TABLE OF CONTENTS

ASUS Title : 0072_STRIX004_SYSTEMFANCONTROL
 <OrgName>
 Engineer: Johnson
 Size Project Name Rev
 B D702BS 1.00X
 Date: Wednesday August 17, 2022 Sheet 72 of 76

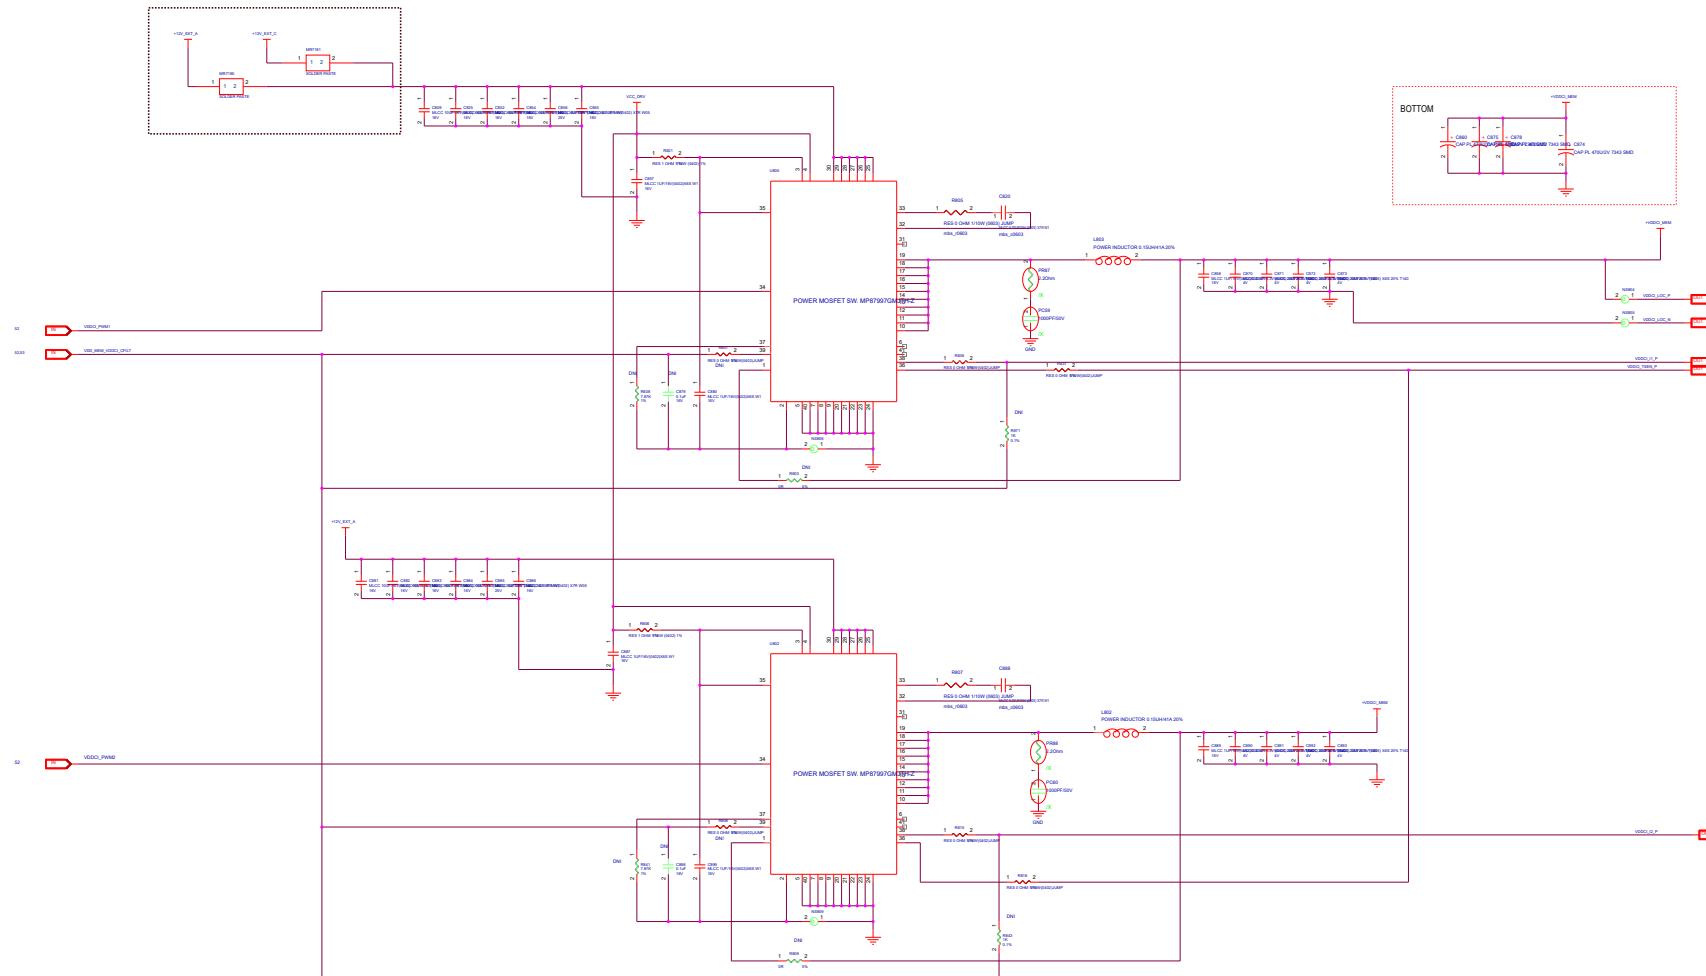
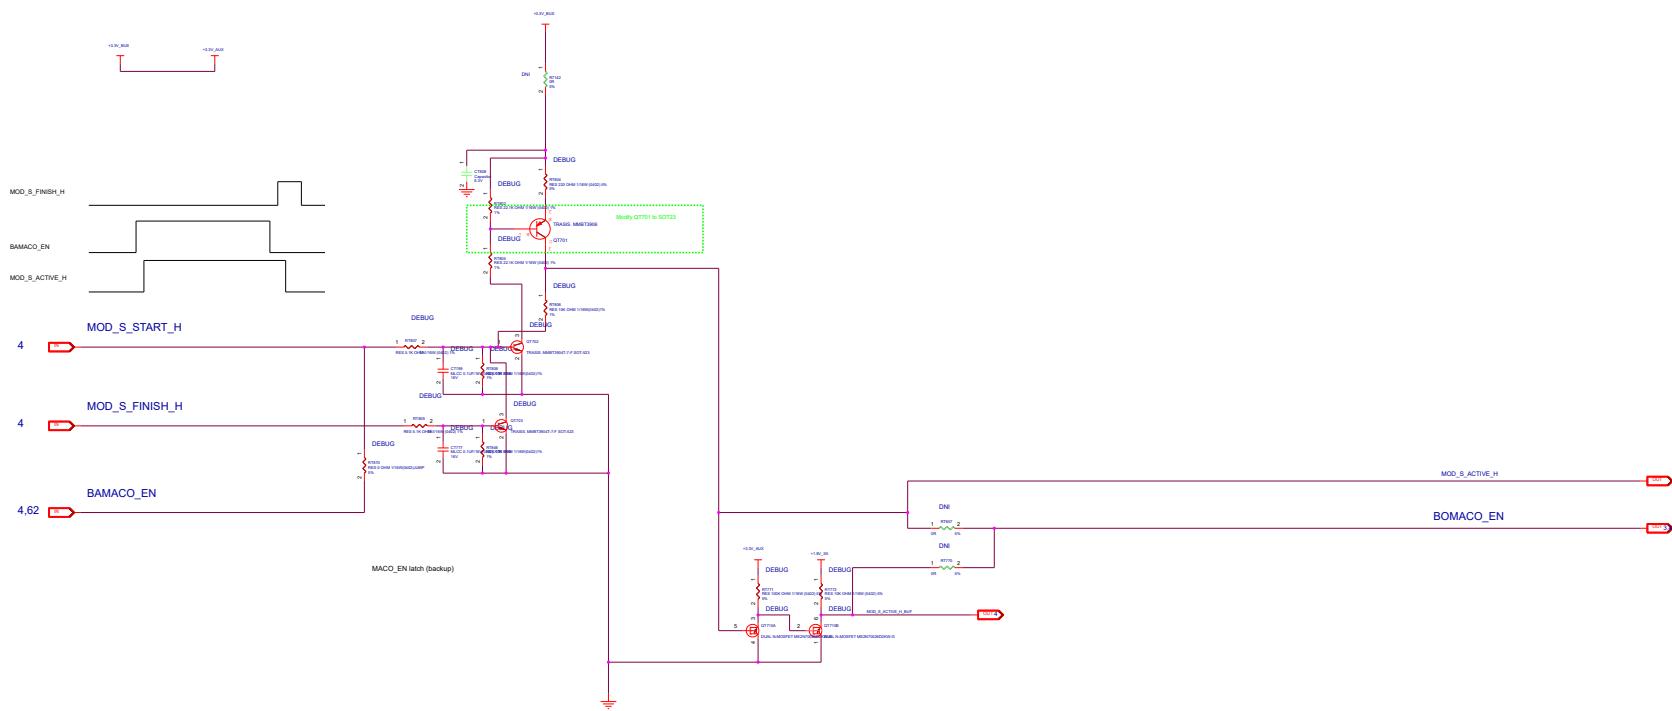
GFX V12 Input Cap, put 5 on top layer and 5 on bottom layer

SOC V12 Input Cap, put 1 on top layer and 1 on bottom layer

Memory V12 Input Cap put 1 on top layer and 1 on bottom layer

Modify by Wade

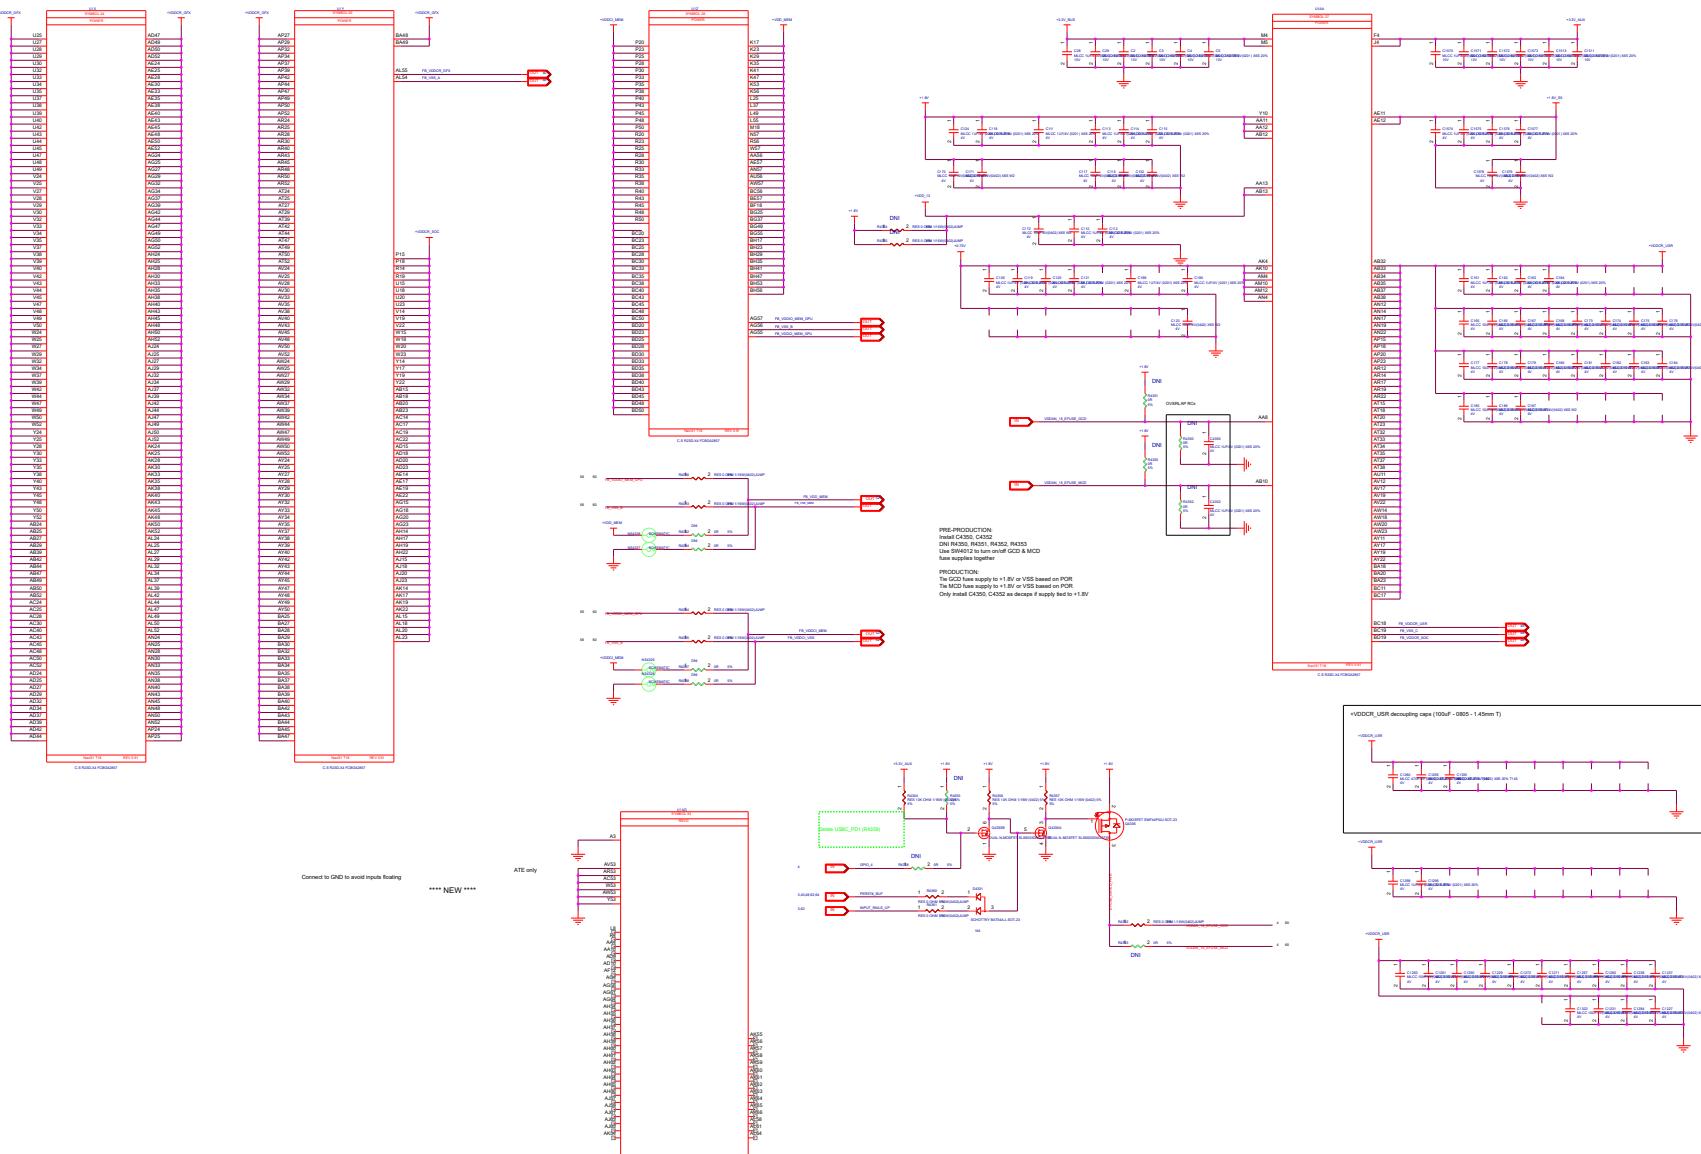
Delete U3039 / U3035 / U3032 / U3033 / U3034 / U3037 / U3038 / U3036
Delete GFX_PCC Net

OPTION for I2C RGB LED bar

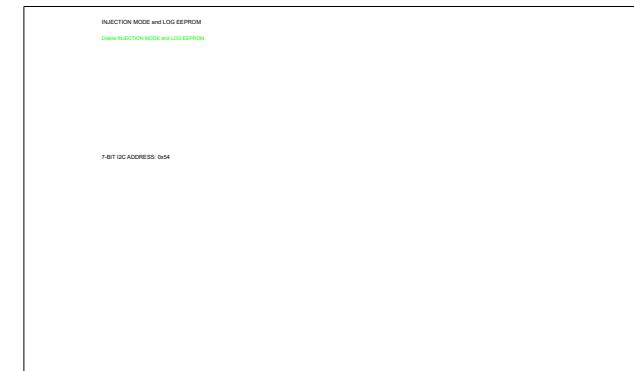
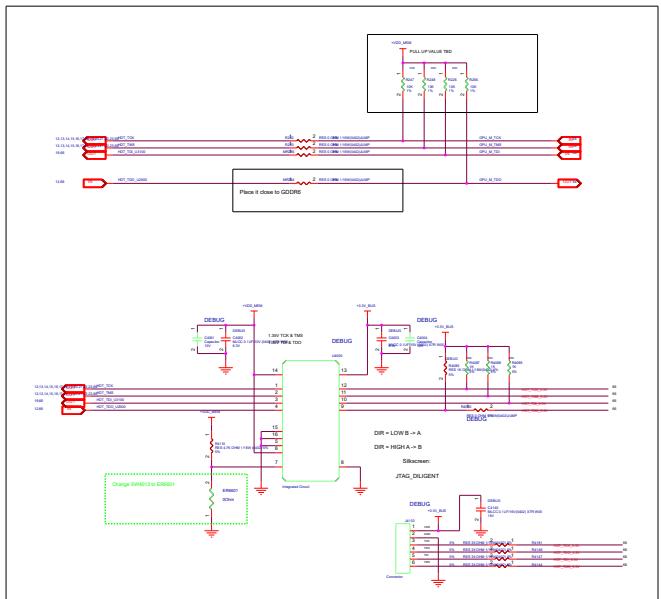
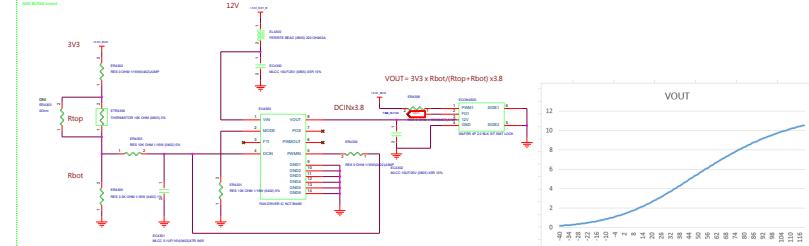
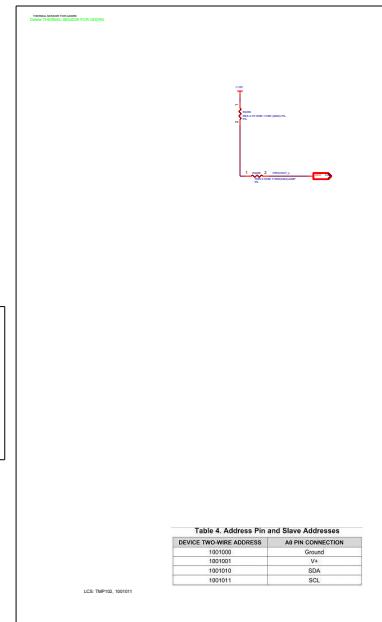
Delete RGB LED header
Delete RADEON Lightbar header

P/Q mode switch

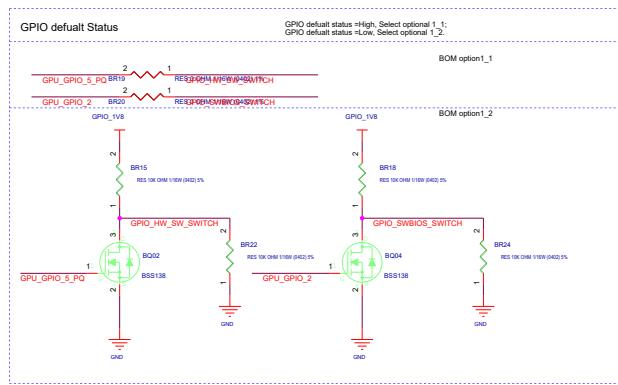
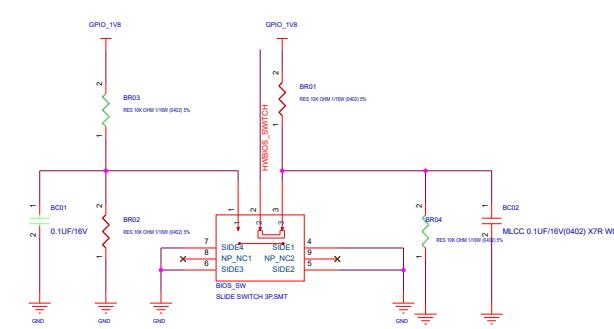
Please confirm whether ROMQ_CS_R and ROMP_CS_R* are pulled up to a high level.
